COMMUNITY DEVELOPMENT DEPARTMENT REPORT

HEARING DATE: 1/14/2025
Continued from: 1/7/2025

SUBJECT: [H-2024-0037](#)
Pollard North - PP, RZ

J. Revisions since Commission Hearing

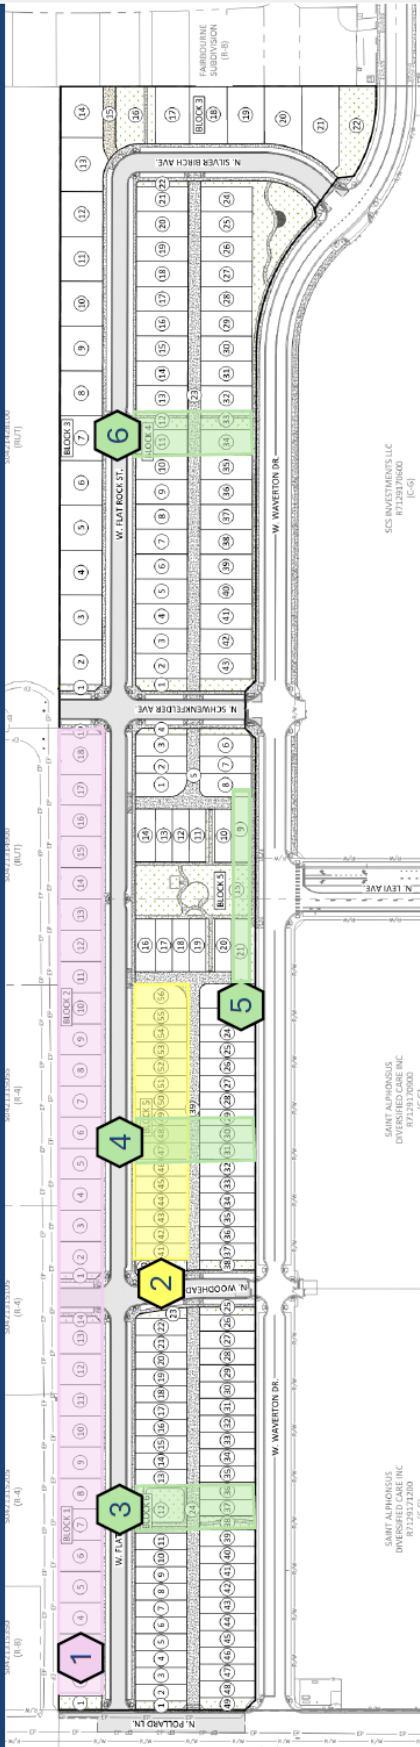
The revised plans include a reduction of 20 building lots (an 11.3% decrease), an increase in the width of the lots along the northern boundary between Pollard Ln. & Schwenkfelder Ave. from 50 feet to 60 feet and replacement of some internal single-family attached/paired units with detached units and open space resulting in a decrease in density from 8.96 to 7.95 units per acre, an increase of 3.4% in qualified open space, and additional pedestrian access points (see original vs. revised layout below in Section VII.J). The project is also now proposed to develop in two (2) phases rather than one (1).
